City of Boise ADA  
Assessment

# Appendix A-City of Boise Zoo

Report #TO21-B023

**Location** AED near Gift Shop Restroom  
**Schedule** 2021  
**Estimated Cost:** \$100.00

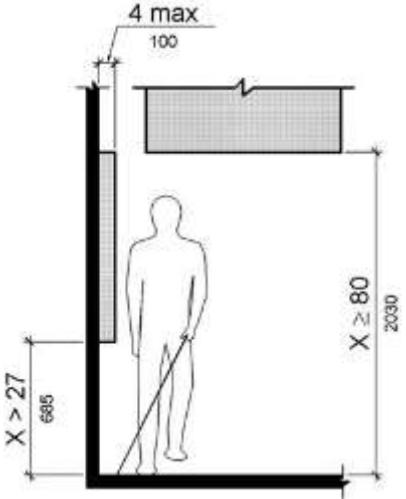
**2010 ADA Standards for Accessible Design Codes §307.2**  
The AED protrudes 6.5" into the circulation space at 38" above the floor.

Recess the AED so it protrudes a maximum of 4" or place a cane detectable object beneath it.

**Location** African Plains Exhibit Animal Presentation Area  
**Schedule** 2021  
**Estimated Cost:** \$100.00

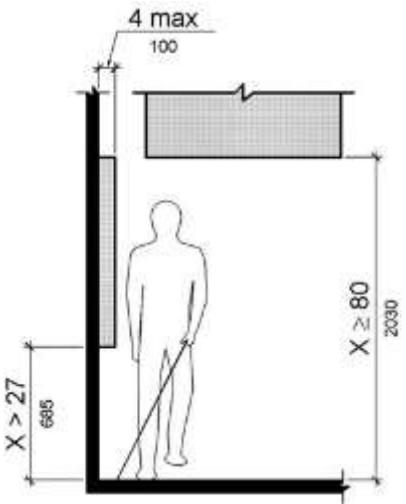
**2010 ADA Standards for Accessible Design Codes §307.2**  
The box protrudes 9" into the circulation space at 36" above the floor.

Recess the box so it protrudes a maximum of 4" or place a cane detectable object beneath it.

**Location** African Plains Exhibit Travel Center  
**Schedule** 2021  
**Estimated Cost:** \$100.00

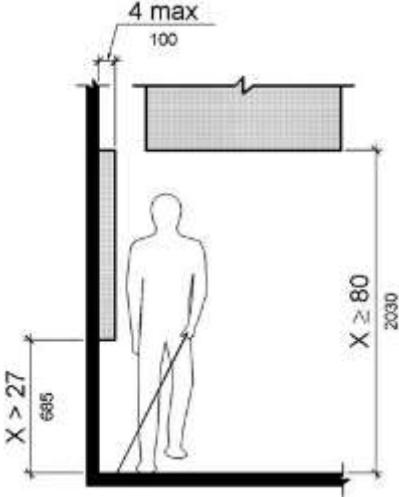
**2010 ADA Standards for Accessible Design Codes §307.2**  
The lamp protrudes into the circulation space at 74" above the floor.

Raise it so the bottom edge is 80" maximum above the floor.

**Location** African Plains Men's Restroom  
**Schedule** 2021  
**Estimated Cost:** \$100.00

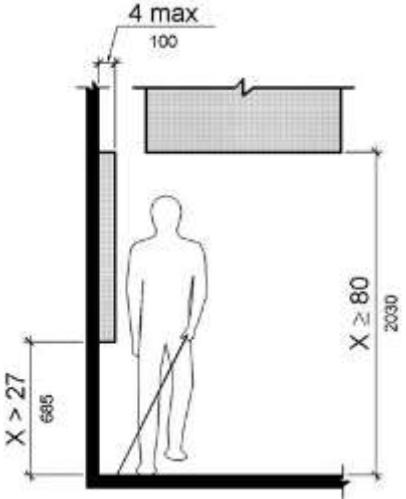
**2010 ADA Standards for Accessible Design Codes §307.2**  
The paper towel dispenser protrudes 10" into the circulation space at 42" above the floor.

Recess the paper towel dispenser so it protrudes a maximum of 4" or place a cane detectable object beneath it.

**Location** African Plains Men's Restroom  
**Schedule** 2021  
**Estimated Cost:** \$100.00

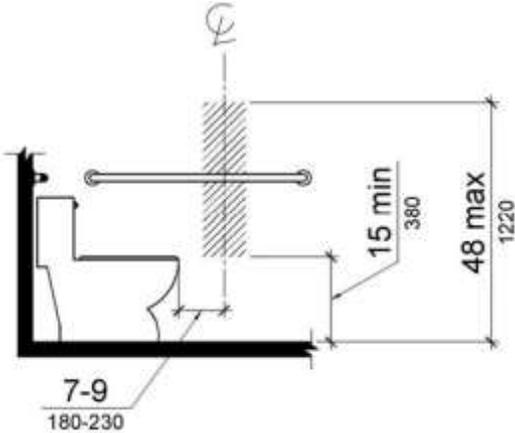
**2010 ADA Standards for Accessible Design Codes §604.7**  
The toilet paper dispenser is located out of the accessible reach range.

Remount the toilet paper dispenser to 7" minimum and 9" maximum in front of the water closet measured to the centerline of the dispenser.  
The outlet of the dispenser shall be 15" minimum and 48" maximum above the floor and shall not be located behind the water closet.

**Location** African Plains Men's Restroom  
**Schedule** 2022  
**Estimated Cost:** \$1,000.00

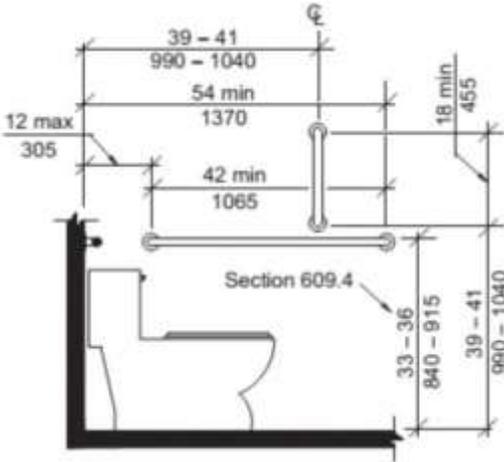
**2010 ADA Standards for Accessible Design Codes** ICC A117.1 §604.5.1  
The accessible water closet does not have a vertical grab bar.

Install an 18" long (minimum) vertical grab bar on the side wall. The grab bar shall be mounted with the bottom located at 39" minimum and 41" maximum above the floor.  
The centerline of the vertical grab bar shall be located 39" minimum and 41" maximum from the real wall.

**Location** Animal Care Staff Break/Office Area  
**Schedule** 2021  
**Estimated Cost:** \$100.00

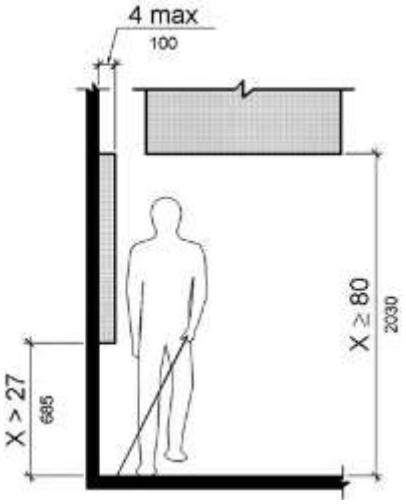
**2010 ADA Standards for Accessible Design Codes** §307.2, §308.2.1  
The first aid box is outside of the unobstructed forward reach range at 52" above the floor.  
The first aid box protrudes 7" into the circulation space at 52" above the floor.

Lower the first aid box by 4" to meet the accessible reach range of 15" minimum and 48" maximum above the floor.  
Recess the first aid box so it protrudes a maximum of 4" or place a cane detectable object beneath it.

**Location** Animal Care Staff Break/Office Area Men's Restroom  
**Schedule** 2021  
**Estimated Cost:** \$100.00

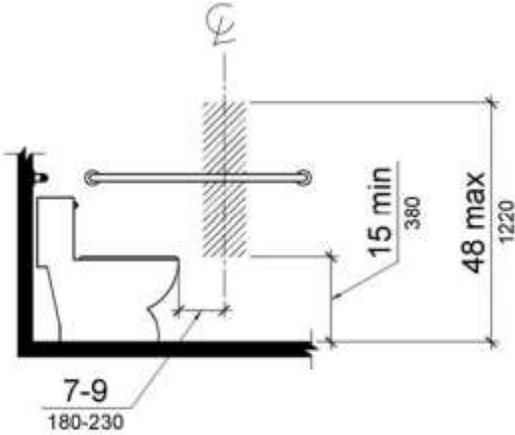
**2010 ADA Standards for Accessible Design Codes §604.7**  
The toilet paper dispenser is located out of the accessible reach range.

Remount the toilet paper dispenser to 7" minimum and 9" maximum in front of the water closet measured to the centerline of the dispenser.  
The outlet of the dispenser shall be 15" minimum and 48" maximum above the floor and shall not be located behind the water closet.

**Location** Animal Care Staff Break/Office Area Men's Restroom  
**Schedule** 2022  
**Estimated Cost:** \$1,000.00

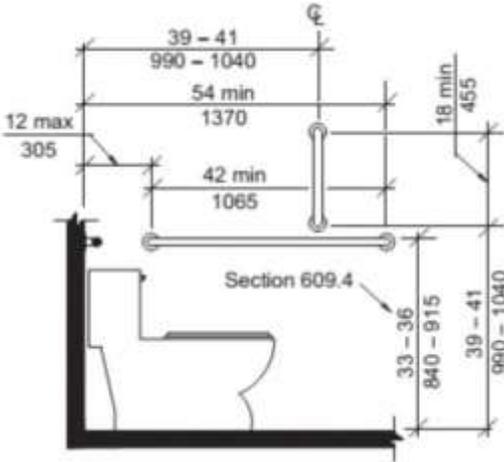
**2010 ADA Standards for Accessible Design Codes** ICC A117.1 §604.5.1  
The accessible water closet does not have a vertical grab bar.

Install an 18" long (minimum) vertical grab bar on the side wall. The grab bar shall be mounted with the bottom located at 39" minimum and 41" maximum above the floor.

The centerline of the vertical grab bar shall be located 39" minimum and 41" maximum from the real wall.

**Location** Animal Care Staff Break/Office Area Ramp to Lunch Area  
**Schedule** 2021  
**Estimated Cost:** \$500.00

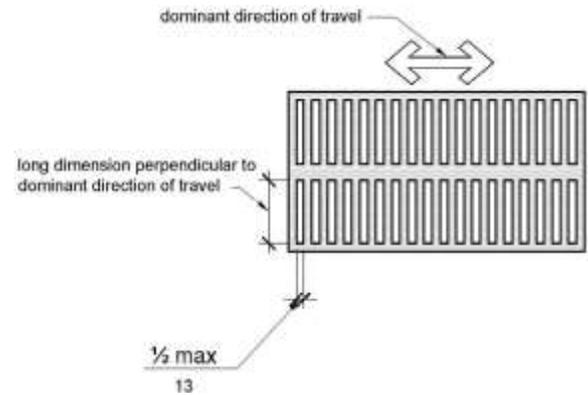
**2010 ADA Standards for Accessible Design Codes** §302.3  
There is a 1" in the pathway posing a tripping hazard.

Fill in the gap to reduce the gap to a maximum of 0.5".

**Location** Education Building  
**Schedule** 2022  
**Estimated Cost:** \$2,500.00

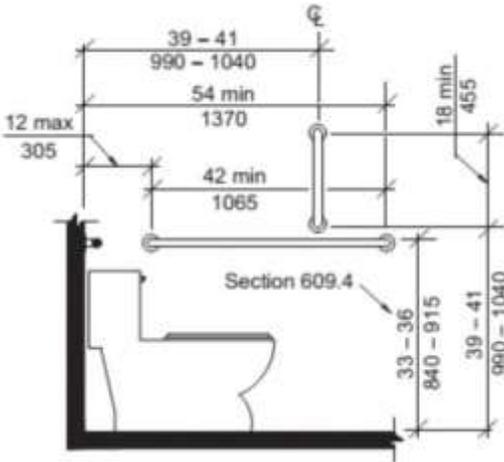
**2010 ADA Standards for Accessible Design Codes** §604.5, ICC A117.1 §604.5.1  
The accessible water closet does not have a vertical grab bar. There are no grab bars.

Install a side and rear grab bar at a minimum height of 33" and maximum height of 36" above the finish floor. The side grab bar shall have a minimum length of 42". The side grab bar shall begin at a maximum of 12" from the back wall.
